SERVICE
NOTES

SN 80131

GOLDEN EAGLE MARK IV

RECEIVER

GOLDEN EAGLE MK IV
RECEIVER

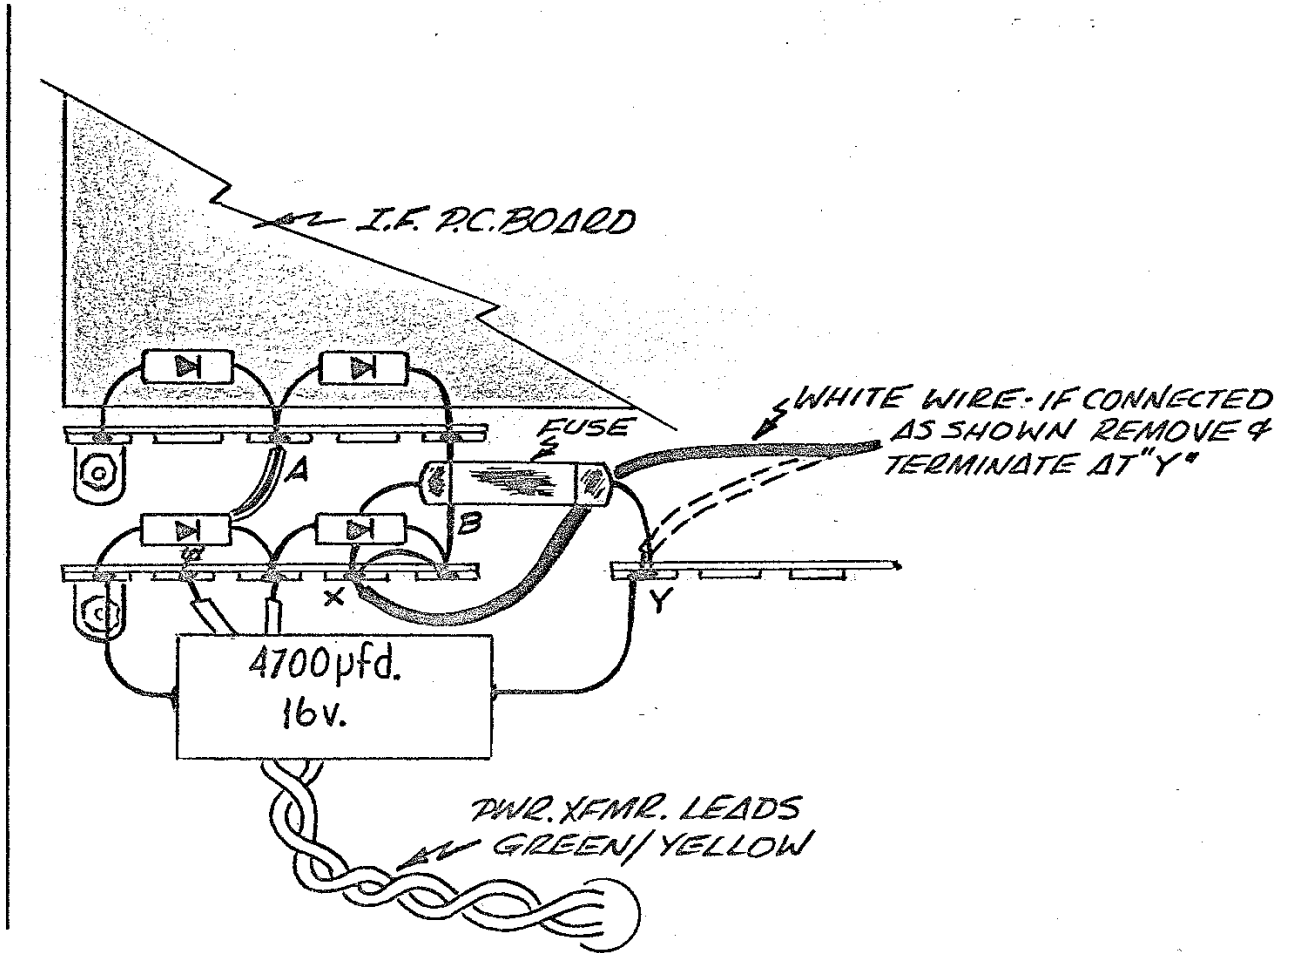
PROBLEM: Failure of the +11 V. Rectifier Bridge D3
(PD1011 or PD1560) due to high initial surge
current.

SOLUTION: Replace the bridge with four individual
3A. 400 P.I.V. diodes.
(Refer to attached diagram.)
Some sets may not have the 3A. fuse and some
have two 2200 MFD capacitors instead of the
4700 MFD.

CAUTION! Do not use these diodes to replace the high
voltage supply as these must be 1000 P.I.V.
or greater.

- 1 S/N 6-0019 TERMINAL STRIP 5-H4A
- 4 S/N 7-0131 DIODE, 3A. 400P.I.V.

FOR JUMPERS "A" & "B" USE
20 BUSS WIRE WITH PLASTIC
SLEEVING OVER "A"
